# Nuclear Reactor Laboratory

Subject: Docket 50-156, License R-74  
Response to Request for Additional Information  
for License Renewal to Facility License No. R-74  
University Of Wisconsin Nuclear Reactor  
TAC No. ME1585 (Technical RAI)

## UWNR Response to NRC Request for Additional Information

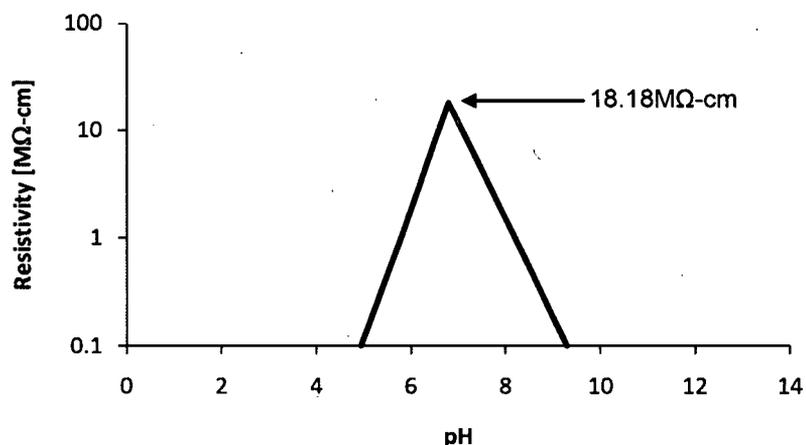
Proposed UWNR TS 3.3 contains limits on primary water conductivity but does not contain a limit on pH. NUREG-1537, Chapter 5, Reactor Coolant Systems, Section 5.2, Primary Coolant System, requests applicants to provide coolant quality requirements, including pH. Please explain why a limit on pH is not necessary to limit corrosion of fuel cladding and other materials in the reactor pool; or propose and justify a limit on pH.

The pH of water is defined as the negative logarithm of the hydrogen ion  $[H^+]$  concentration, or  $-\log_{10}[H^+]$ . In pure water a constant dissociation and recombination of the hydrogen ion  $[H^+]$  and hydroxyl ion  $[OH^-]$  occurs as shown in the equation below and is temperature dependent<sup>1</sup>.

At 25°C, the  $[H^+]$  concentration is  $1.004 \times 10^{-7}$  mol/L and therefore the resulting pH is 6.998. As a result it is challenging to measure the pH of pure water due to the near absence of ions that would enable electron transport between the measuring and reference sides of a pH electrode. Furthermore, adding the slightest amount of acid or base to pure water will change its pH significantly. As an example, pure water readily absorbs carbon dioxide ( $CO_2$ ) when exposed to atmosphere which forms carbonic acid,  $H_2CO_3$ , a weak acid. Even the absorption of fractions of a  $\mu\text{g}/\text{kg}$  (parts per billion, ppb) concentration will ultimately lead to a pH of approximately 5.8<sup>2</sup>.

A more accurate method of determining pure water quality is by measuring its conductance, or conversely, its resistance. Conductivity measures the flow of electrons through a fluid, which is proportional to the concentration of ions in the fluid. As noted above, in pure water at 25°C, the  $[H^+]$  concentration is  $1.004 \times 10^{-7}$  mol/L and therefore the resulting conductivity is 0.055 S/cm, or its resistivity is 18.18M $\Omega$ -cm. Therefore a measure of conductance or resistance can predict the absolute range of pH as shown in the figure below<sup>1</sup>. This method is also the method required for pure water quality measurements as promulgated by the International Organization for Standardization, ISO 3693:1987.

UWNR TS 3.3.3 contains a limit on primary water conductivity to be less than 5 micromhos/cm (note: 1 micromho is equal to 1 $\mu$ S) or in terms of the resistivity (the actual parameter measured) greater than 0.2 M $\Omega$ -cm. As a result the absolute possible range of pH would be between 5.58 and 8.42 which is consistent with the acceptance criteria of NUREG-1537, Part 2, Guidelines for Preparing and Reviewing Applications for the Licensing of Non-Power Reactors, Standard Review Plan and Acceptance Criteria, section 5.2.

Figure 1, Power vs. Time during Simultaneous Control Element Withdrawal

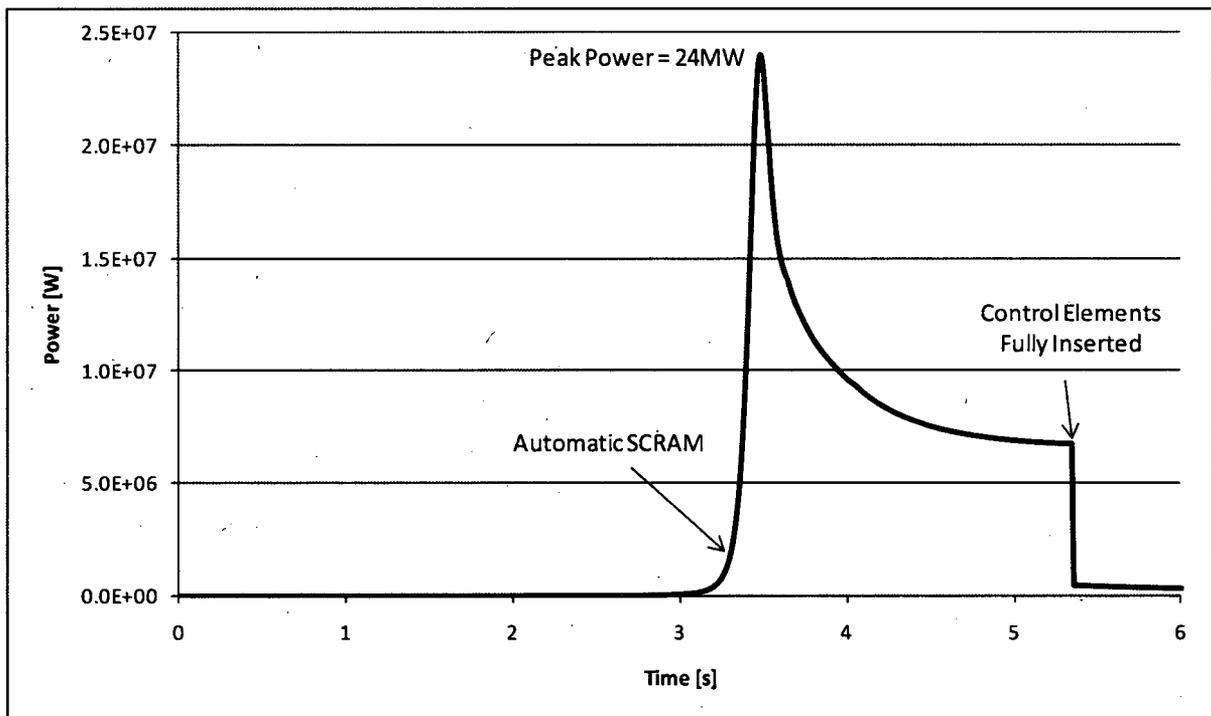
Proposed UWNR TS 3.2.5 does not contain an interlock to prevent the withdrawal of multiple control elements at the same time. NUREG-1537, Chapter 13, Accident Analysis, Section 13.1.2, Insertion of Excess Reactivity, requests applicants to analyze ramp insertions of reactivity. Please analyze and discuss a reactivity addition event based on the withdrawal of the maximum number of control elements possible in accordance with your TSs. Please discuss the results of the analysis as compared against the safety limit for the reactor.

The maximum total reactivity insertion rate is 18.1 % $\Delta$ k/k per minute, or 0.302 % $\Delta$ k/k per second. The RELAP5/MOD3.3 2-channel model from the LEU Conversion SAR was used to model this reactivity insertion rate starting with the reactor critical below the point of adding heat. The calculated core power exceeds 1.3MW at 3.36 seconds following the start of the ramp insertion, at which time the automatic power level scram would be initiated. For conservatism, the control elements are assumed to continue withdrawing at the maximum

reactivity insertion rate for an additional two seconds, which is the maximum allowable scram time, at which time they are instantaneously and fully inserted. The peak power of 24.0MW occurs at 3.49 seconds as seen in Figure 1, a full 1.87 seconds before the control elements even insert, due to the inherent large prompt negative fuel temperature coefficient of reactivity of TRIGA fuel. The peak fuel temperature of 434°C occurs at 5.36 seconds when the control blades are assumed to be fully inserted, as seen in Figure 2. The total energy release is 19.6MJ.

The peak fuel temperature and energy release during this event are less than the values of 663°C and 26.9MJ as calculated for routine pulsing following a step insertion of 1.4%  $\Delta k/k$  as shown in Table 4.7.22 on page 136 of the LEU Conversion SAR. Therefore the simultaneous withdrawal of all control elements is bounded by the routine pulsing analysis in section 4.7.10 of the LEU Conversion SAR and the analyzed rapid addition of reactivity accident postulated in section 13.2 of the LEU Conversion SAR of a step insertion of 1.4%  $\Delta k/k$  while operating at 1.3MW.
